**CONSTRUCTION BULLETIN
No. 1**

Institution: Calipatria State Prison - CAL

Reference: Project #18-045, Replace Roof, Phase 11, including

Description: This bulletin is to revise the roof slope to the existing ¼” per foot and to revise the parallel AHU’s crickets to 1 ½” per foot on the upper roof per RFI 003 response. Plans and Sections have been revised show the updated roof slope. Parapet,

APPROVALS

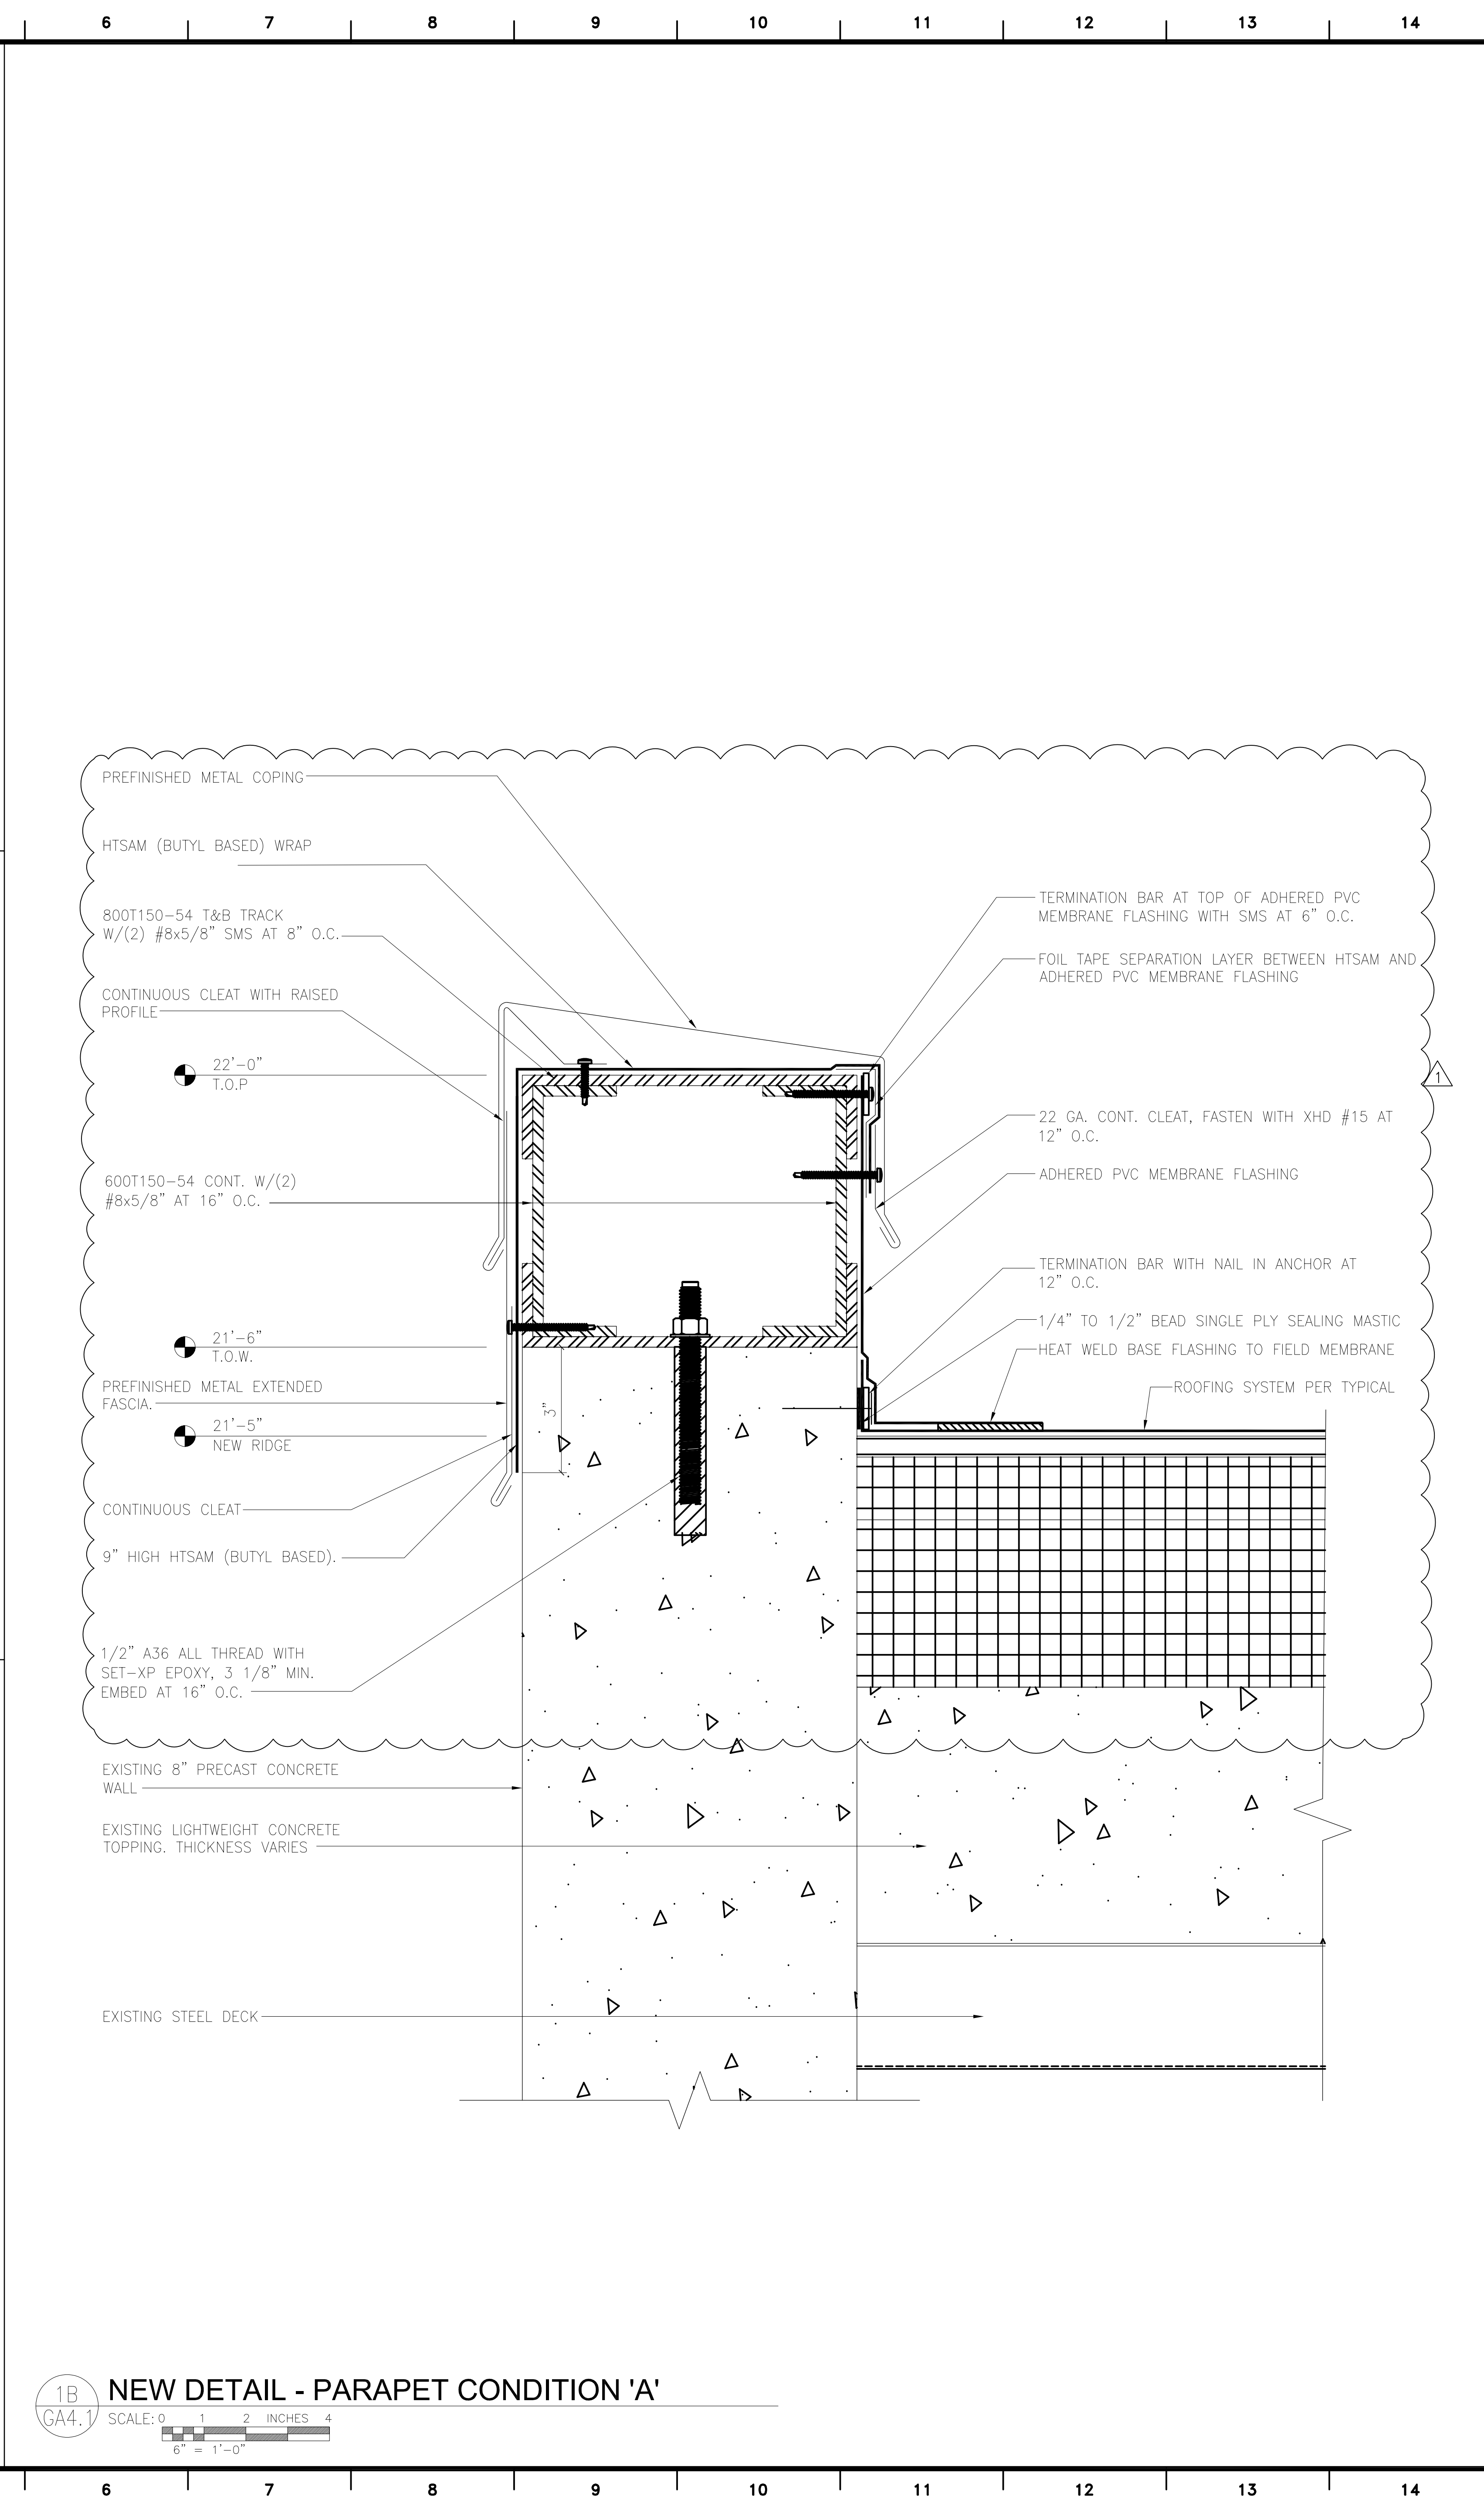
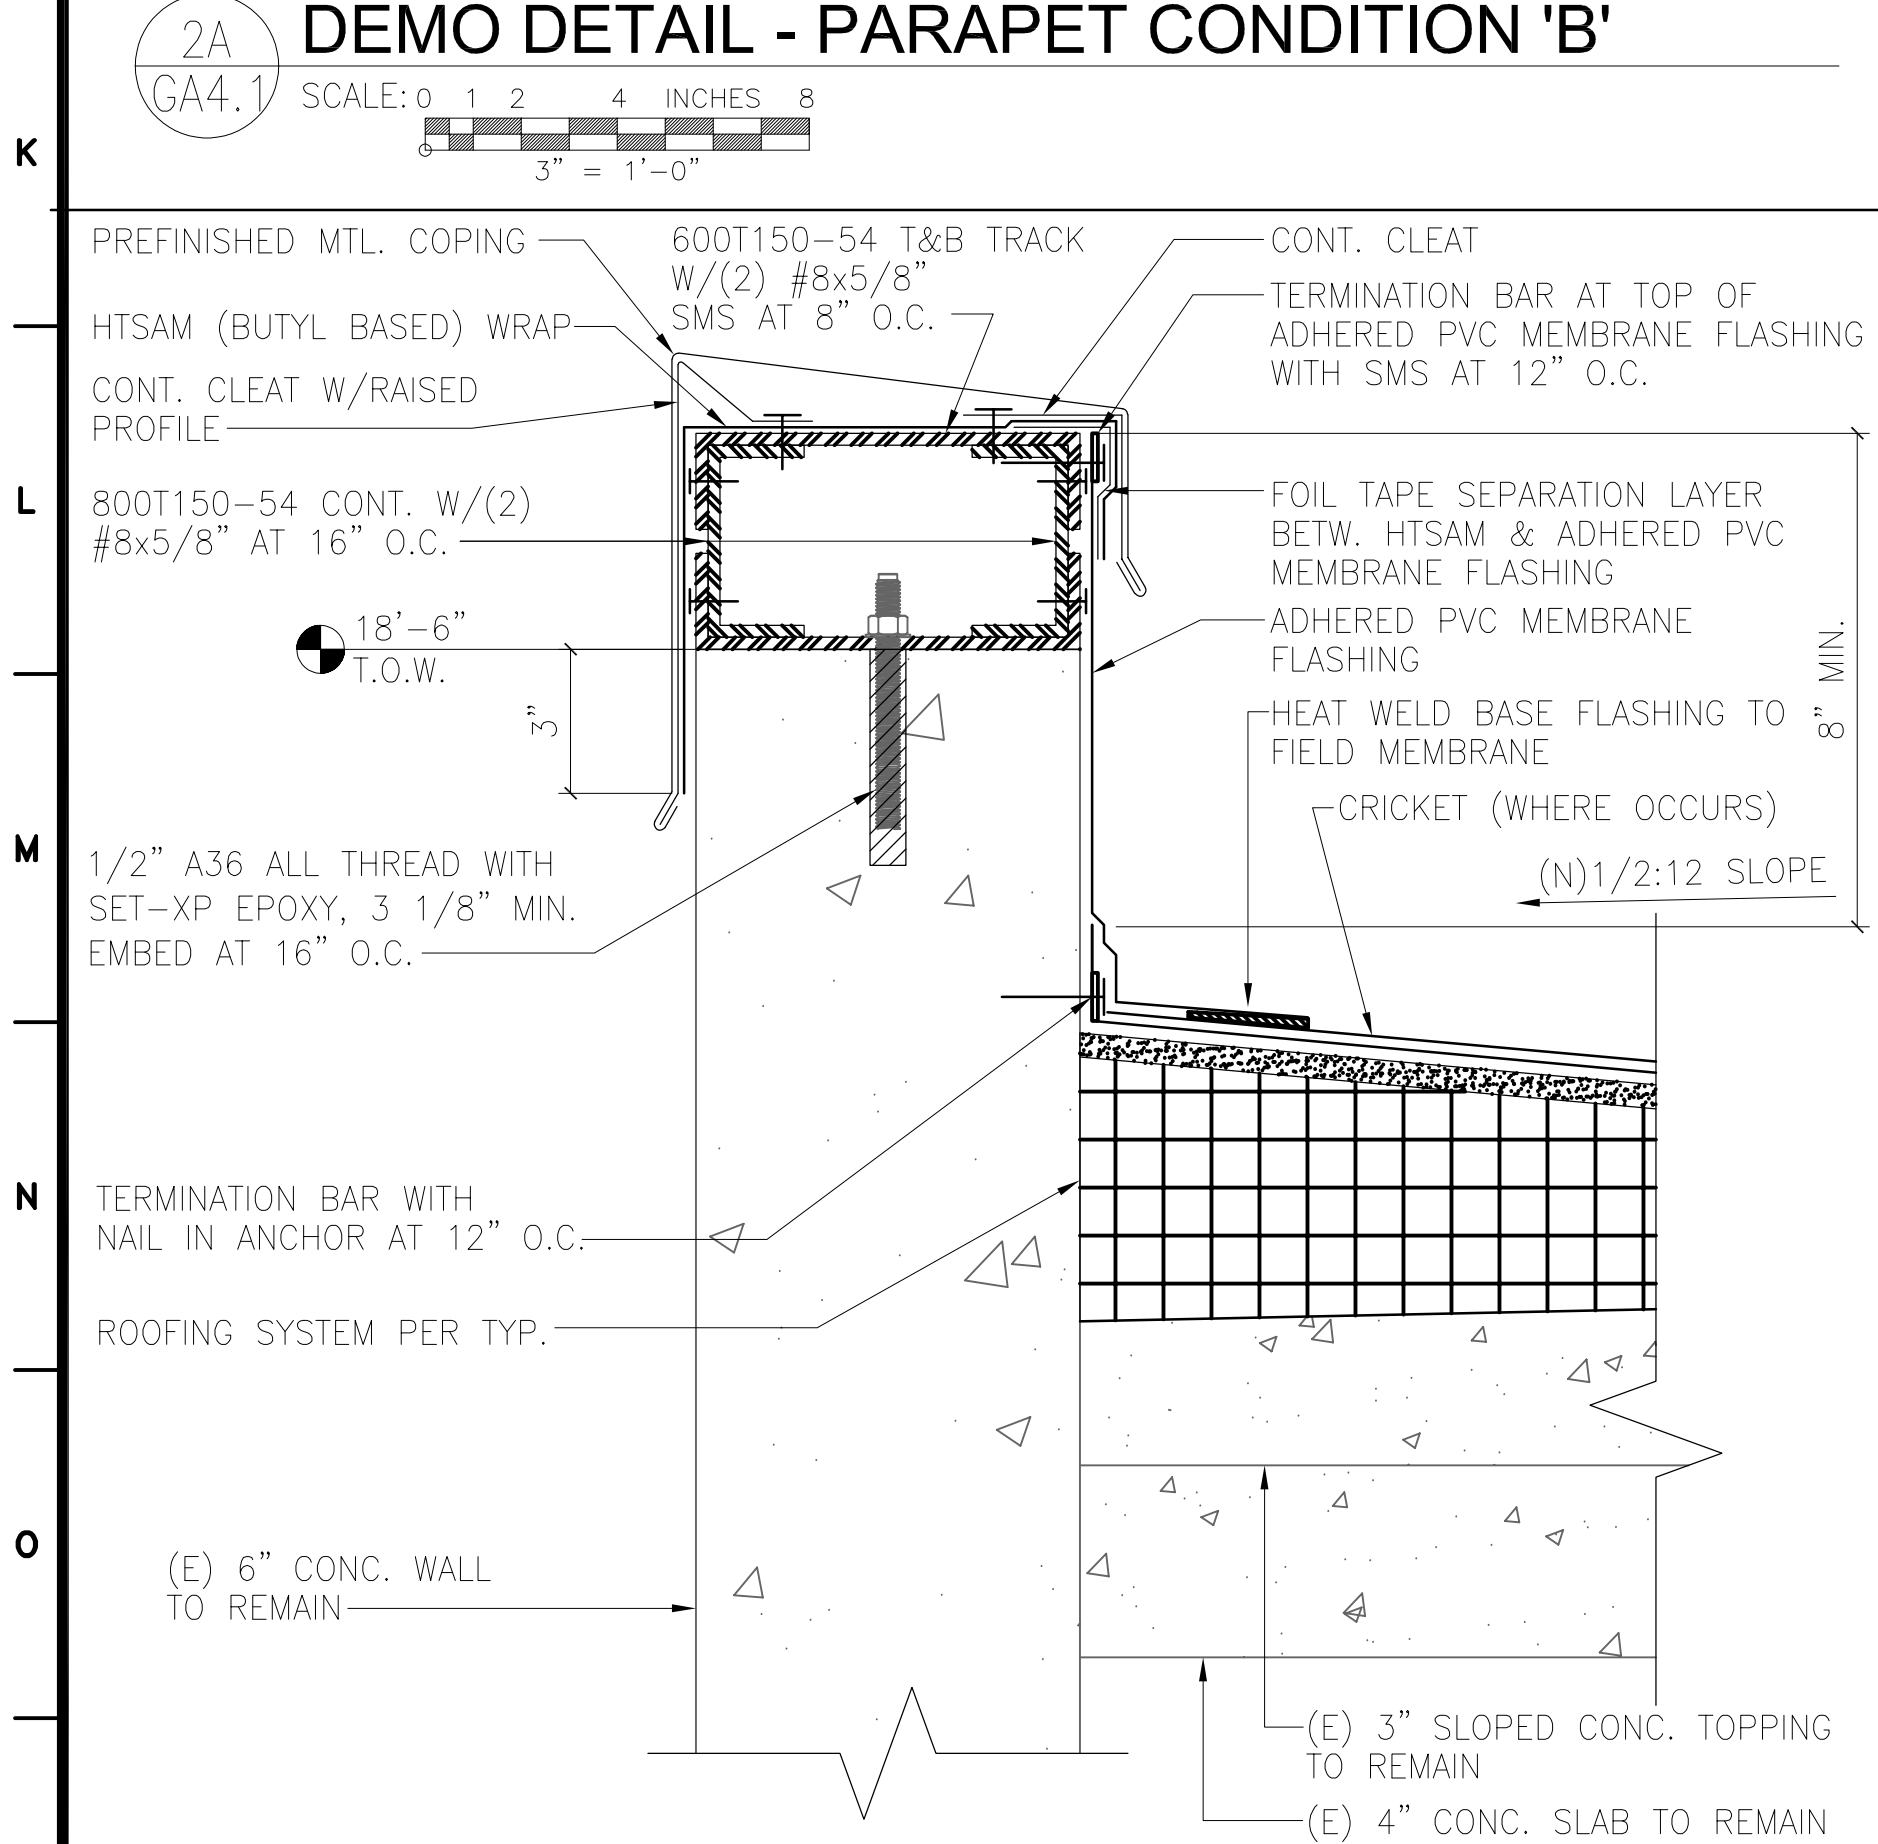
- a. Revised parapet detail to reduce parapet height per reduction of roof slope. See detail 1B/GA4.1.
8. Sheet GA4.2:
 - a. Revised roof edge condition detail per revised roof slope, see detail 3/GA4.2 and 5B/GA4.2.
